## Difference Document

**Product: DM ACX04G version 1**  
**FCCID:WYPACX04G**  
**ICID:8090A-ACX04G**

**Product: DM ACX04G version 1.1**  
**FCCID:WYPACX04G**  
**ICID:8090A-ACX04G**

**DM ACX04G Hardware change.**

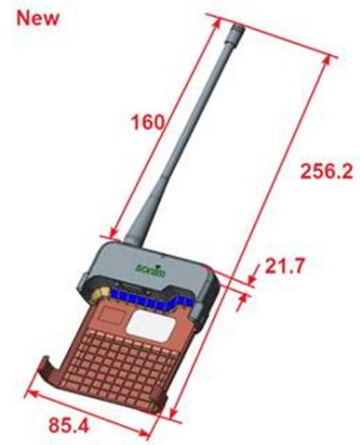
Item	Change from	Change to	Remarks
1 Antenna	Stubby antenna 1/4 wave (length 1.5-inch)	Whip antenna 1/2 wave (length 6-inch)	The max gain can be referred from former TRP checking.
2 Antenna matches	Capacitors 10uF and 20uF	Resistor 0 ohm	
3 Rear housing	rear housing (pure plastic) 	rear housing with back plate (pure plastic) 	Only housing dimension change
4 HW revision	V1	V1.1
